October 24, 2024

Re: 140 Mountain Road, Manorwood Commercial, Town of Collingwood
Addendum No.2 - Functional Servicing Report Fire Flows

Hydraulic Analysis of the 140 Mountain Road Development (DRAFT)

SITE SERVICING PLAN

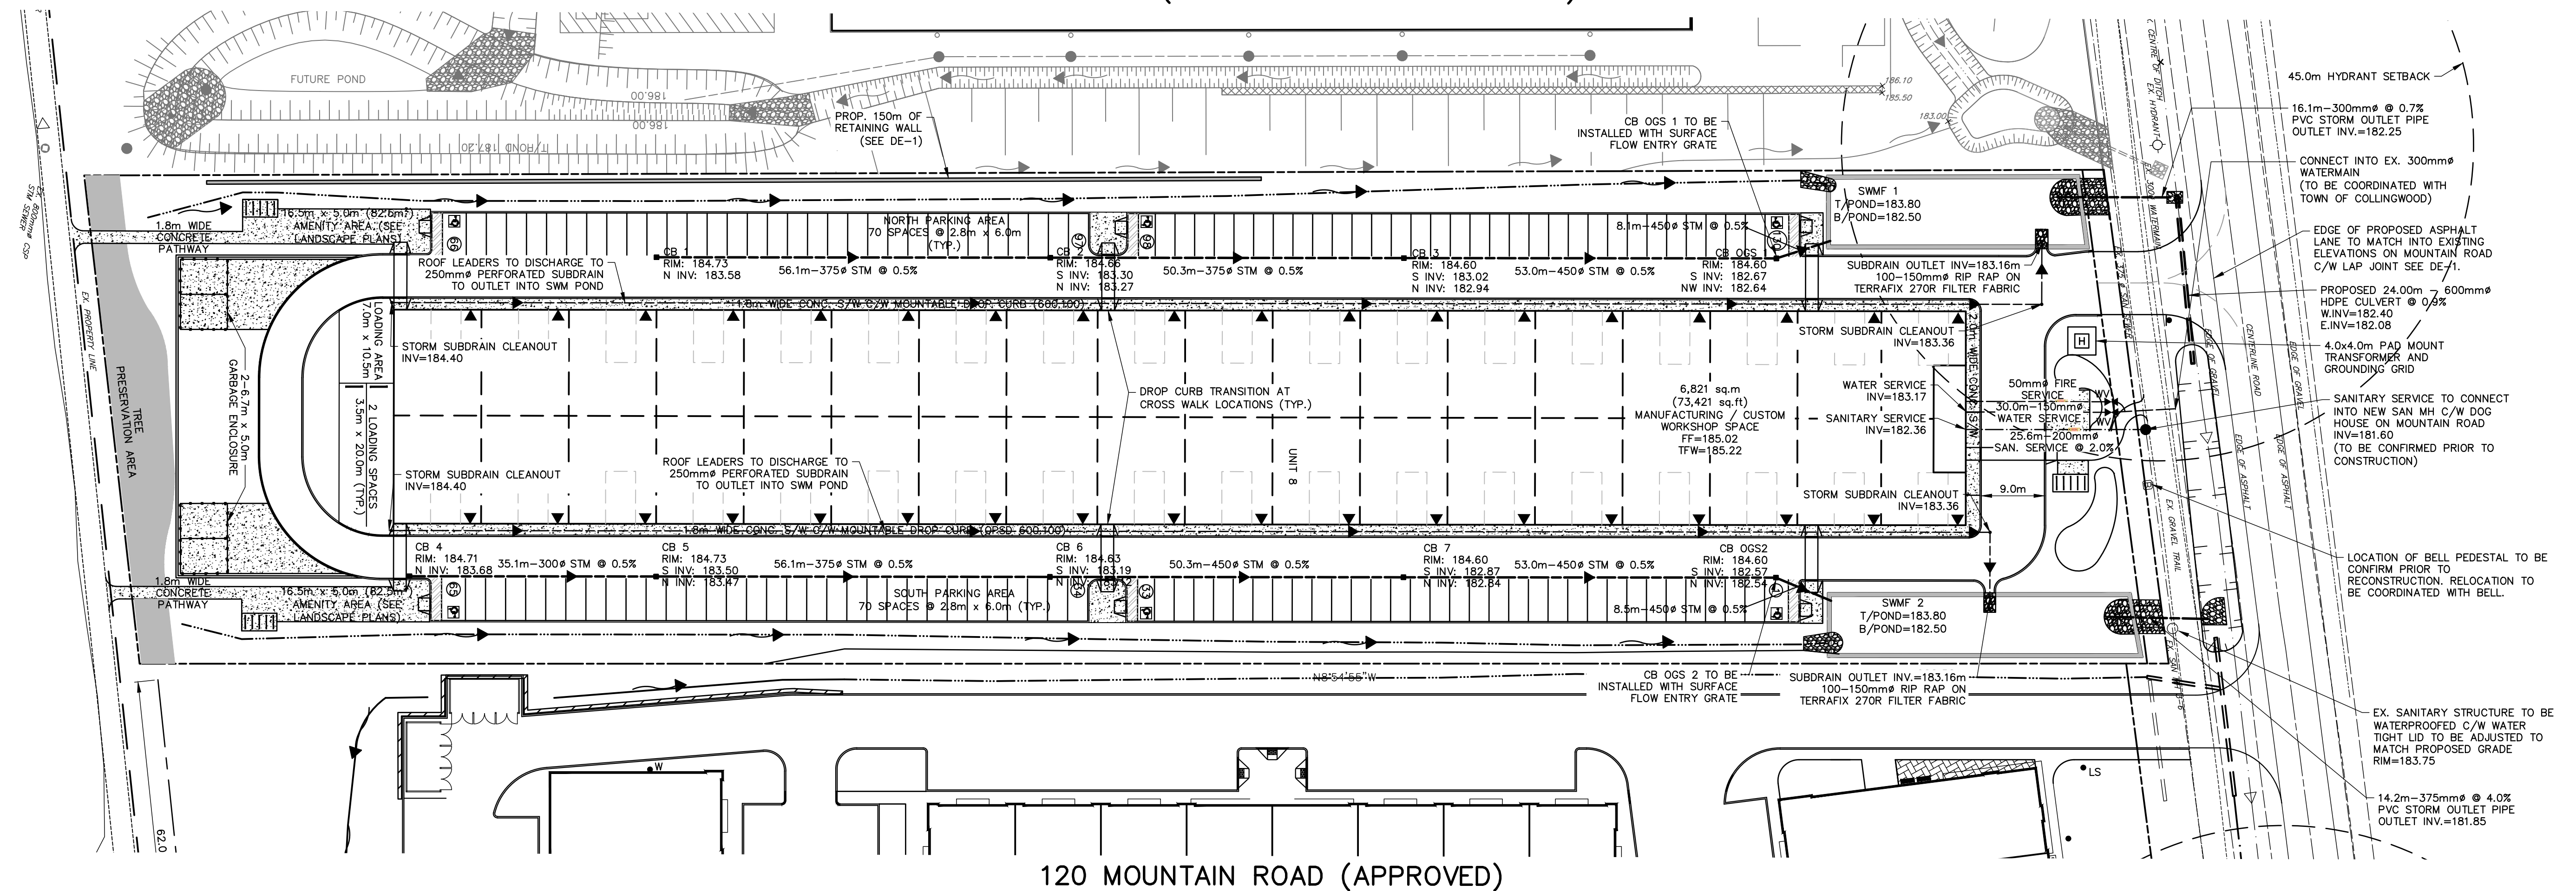
The Town acknowledges receipt of the draft water modelling report dated Thursday, June 20, 2024. Upon review of this report, the Town's fire flow standard of 136 L/s for Industrial/Commercial Subdivisions was not attained. Given this, the current proposed works do not meet the Town's development standards for fire flow. However, the Town is allowing the proposed works to proceed subject to the developer and developer's engineer ensuring all requirements set out in the OBC for supplemental fire systems for the proposed works are met and completed. This will be reviewed by the Town's Building Department through the building permit process. Please be advised that should any revisions be required to the stamped site plan approved drawings to accommodate the design of the required fire protection water supply, a Site Plan Amendment, or other Planning Act applications, may be required.

As a supplemental fire system has not been contemplated thus far for the proposed development, Planning Services requests an addendum to the Fourth Submission which includes a supplemental fire system that your client is satisfied would be compliant with the Ontario Building Code (OBC) prior to progressing a staff report to the Director, Planning, Building and Economic Development for consideration. I note the supplemental fire system will not be reviewed for compliance with the OBC by Building Services until such time as a Building Permit application is submitted. However, should the inclusion of a supplemental fire system have implications on the Site Plan drawings or technical reports that have been reviewed to date (e.g. building footprint, parking/landscaping layout to accommodate water storage, SDUs for servicing capacity, etc.), the revisions to the proposed development will need to be further reviewed against the Town's Zoning By-law, Urban Design Manual, and other applicable policies, as necessary. Should the applicant wish to proceed without providing the requested addendum, the applicant would be doing so at their own risk and the development may be subject to additional future Planning Act applications.

Therefore, in order to compensate for the lack of available fire flow, Tatham propose a 7,500 Litre (2,000 gallon) water storage tank (size to be verified during Building Permit Approval process) be installed and connected to the proposed 200 mm diameter water service within the site prior to entering the mechanical / electrical room. The storage tank will act as a backup to meet the Town's fire flow requirements of 136 L/s. Details of the water storage tank can be found on the revised Site Servicing Plan SS-1 dated October 23, 2023, which has been enclosed as part of this submission.
